Required Hose Clamp Replacement on 5.0 MPI and 350 MAG Alpha Models

Models Covered	Serial Number
5.0 MPI ECT and Non-ECT Alpha Models	2A034632-2A036146
350 MAG ECT and Non-ECT Alpha Models

51262

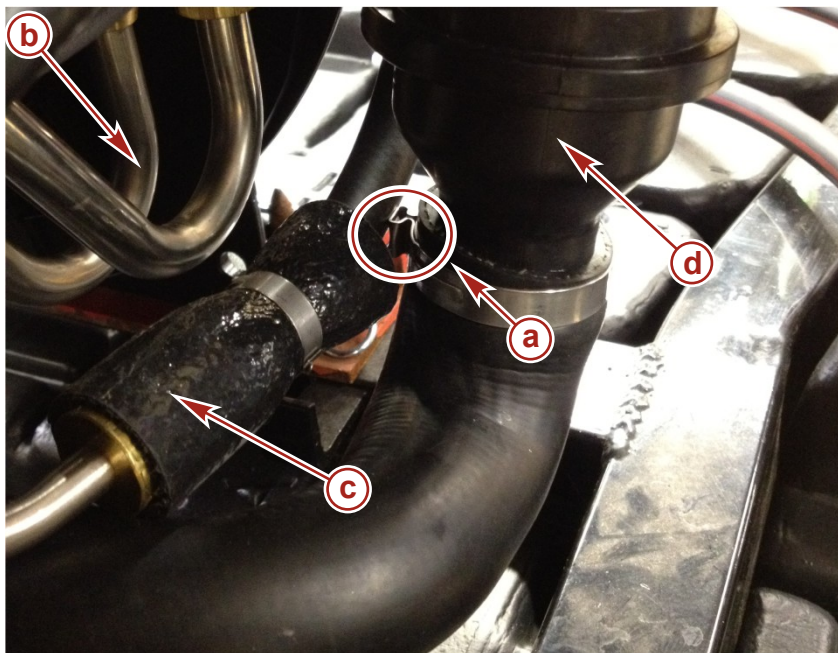
Mercury Marine has determined that the engines within the affected serial number range have a water hose clamp that could contact a fuel line. Over time, if the water hose clamp is touching the fuel line, it may chafe and potentially cause a fuel leak.

- a** - Area of potential interference
- b** - Remote oil filter lines
- c** - Fuel line from Cool Fuel module to fuel rail
- d** - Check valve

The lower Oetiker® clamp on the water inlet hose check valve needs to be replaced with a worm gear hose clamp. The head of the clamp must be positioned outboard to prevent it from coming in contact with the fuel line.

2. Open the worm gear hose clamp all the way to allow it to fit around the hose without disconnecting the hose from the check valve.
3. Install the worm gear hose clamp on the hose, the head of the clamp must be positioned outboard and away from the fuel line.
4. Tighten to the specified torque.

Description	Nm	lb-in.	lb-ft
Hose clamp	5	40	–
